TR-9 Open Source Digital Radio

Title: HMI Board

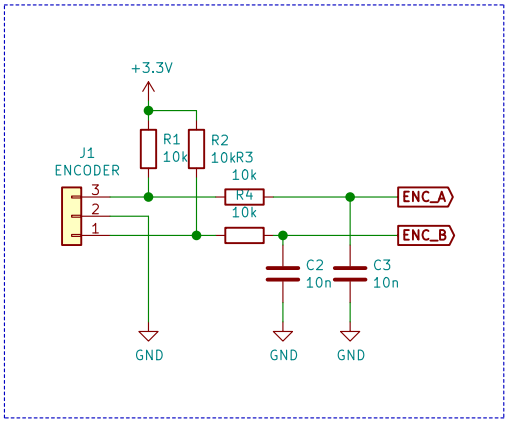
We are using a pot instead – so no longer needed

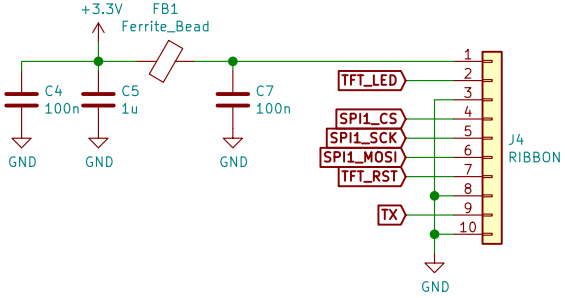
/RD (9) and /WR (8) are tied to GND, assuming we are using 3-wire SPI
